**St Giles Circus**

**MMA Design Statement**

**August 2015 - Rev. 01**

Sub basement

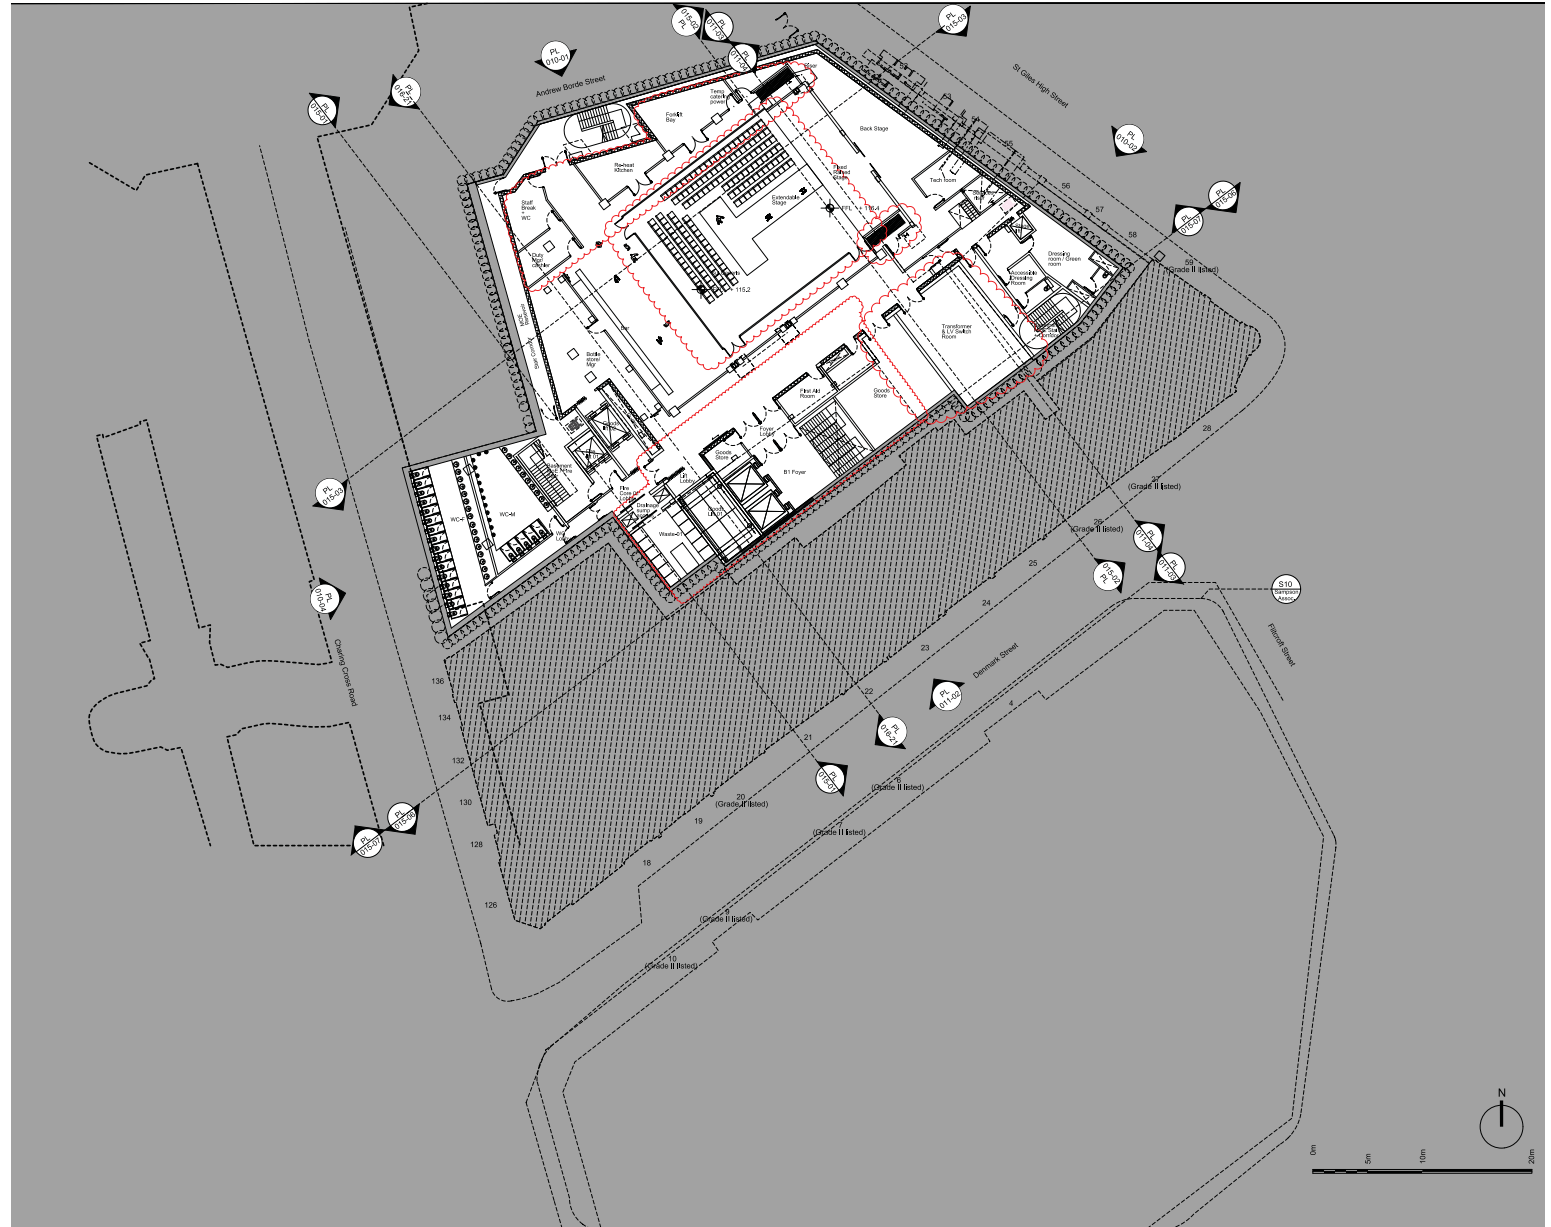
- Realignment of the basement box to respond to site surveys and co-ordination with temporary works for Crossrail project
- Core layout amended

# Proposed Basement

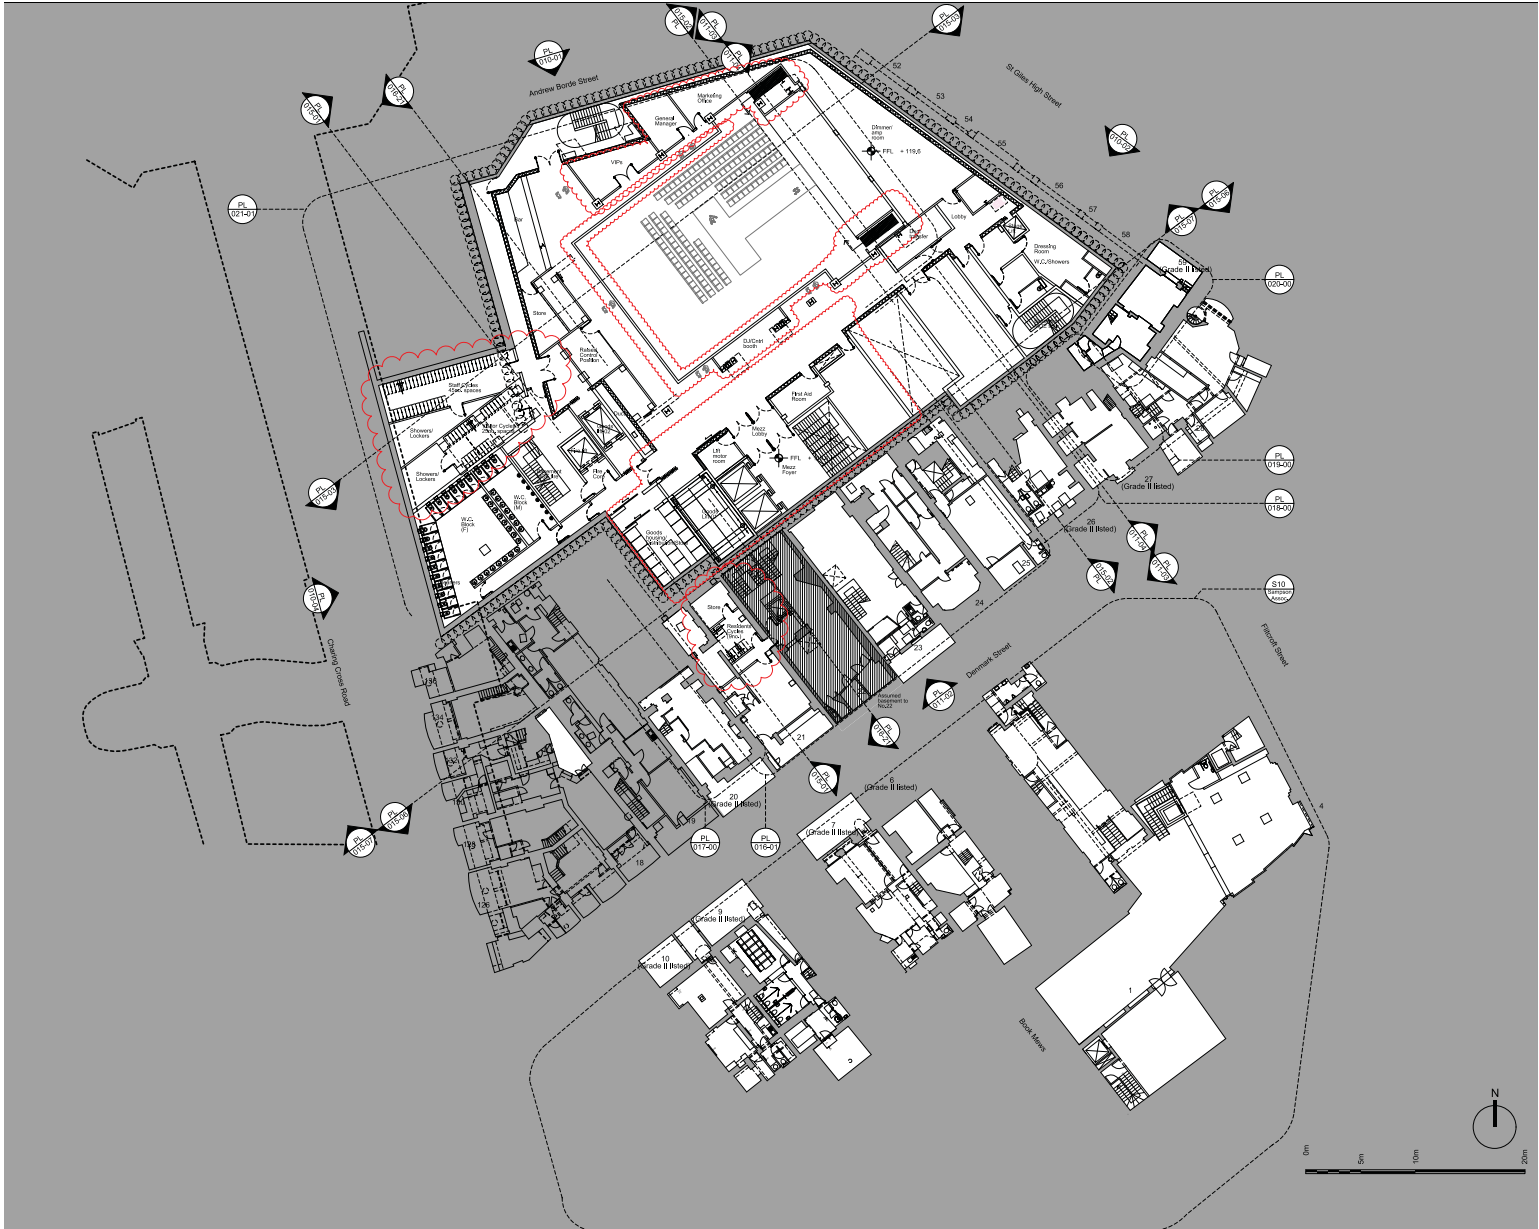
- Realignment of the basement box to respond to site surveys and co-ordination with temporary works for Crossrail project
- Core arrangement amended for the connection to the events gallery

# Proposed Mezzanine

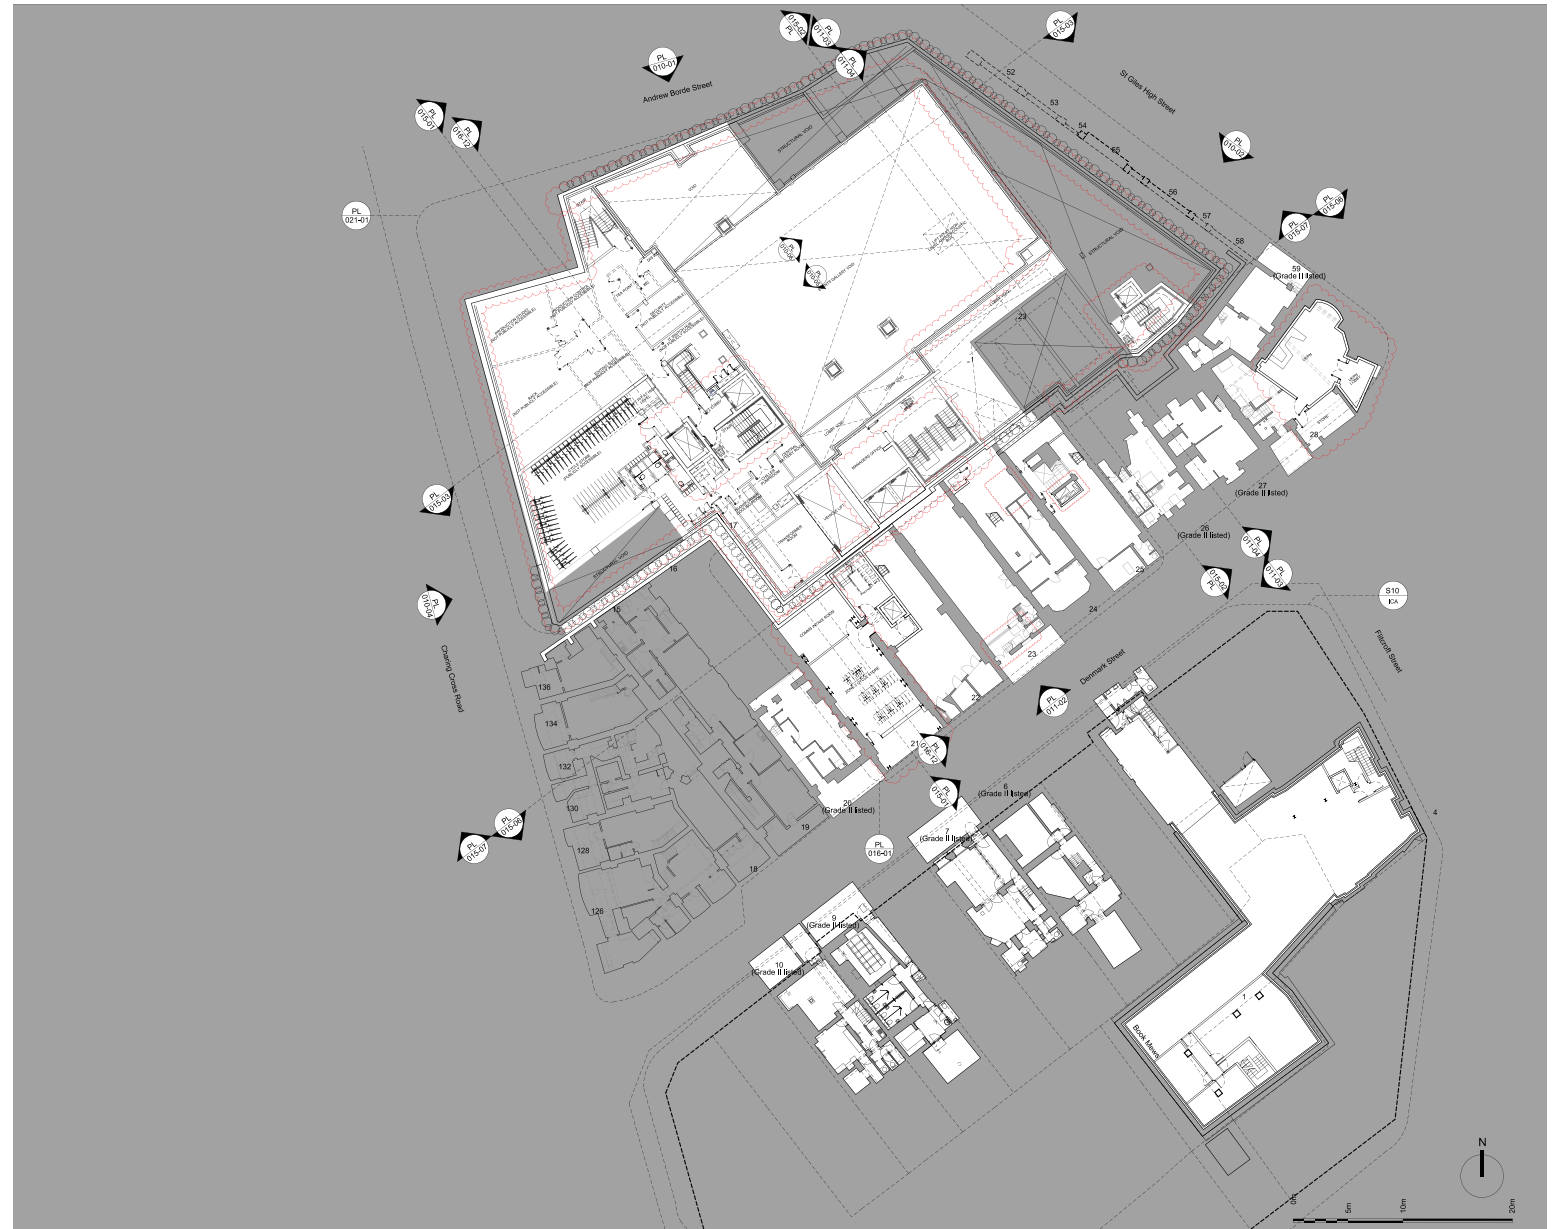
- Core layout amended to increase A1 frontage at Ground level along Denmark Street
- Core from Building C reconfigured with direct access from Denmark Place
